Sicherheitsmitteilung  
SM171001

**Bezug:** SIFE SB 2017-002

## Service Bulletin 2017-002

Subject: Ring position on SIFE main risers

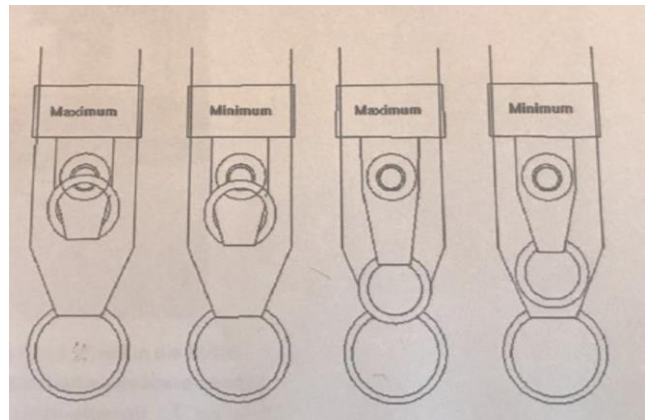
**Grund:** Meldung, dass bei einem Release Funktionstest am Haupttragegurt, die Funktion erst nach händischem Lösen der 3-Ringe gegeben war. Die Herstelleruntersuchung ergab, dass der betroffene Haupttragegurt nicht den Herstellerspezifikationen entsprach

1. Kontrolliere ob die Haupttragegurte, den auf der Abbildung gezeigten Toleranzen entspricht:
2. Sollten die Tragegurte nicht der Herstellerspezifikation entsprechen, oder sollten Unklarheiten auftreten, ist der Hersteller unter: [office@sife.at](mailto:office@sife.at) zu kontaktieren.  
Betroffene Haupttragegurte werden durch den Hersteller kostenfrei ersetzt.

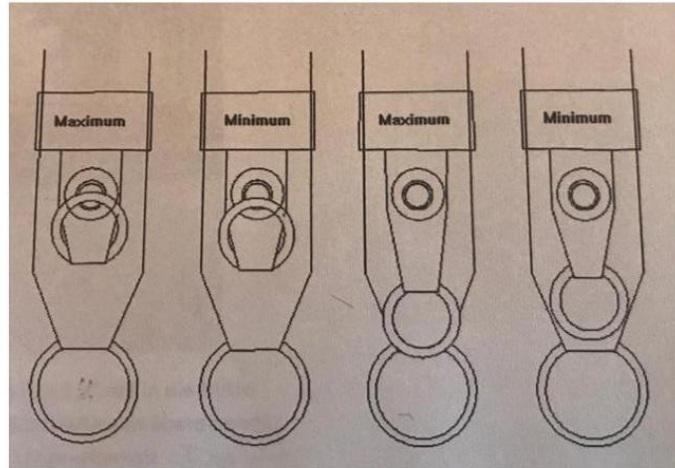
We have been informed that during the simulation of a cutaway procedure, the 3-ring-system released only after a short tug on the risers. The result of our investigations is that the position of the small ring on the affected main risers may not meet the design specifications.

1. Check the ring position on your main risers with the following figure:

2. If your main risers do not meet the design specifications, or if you are unsure please send us an e-mail to [office@sife.at](mailto:office@sife.at).

The main riser replacement will be free of charge.
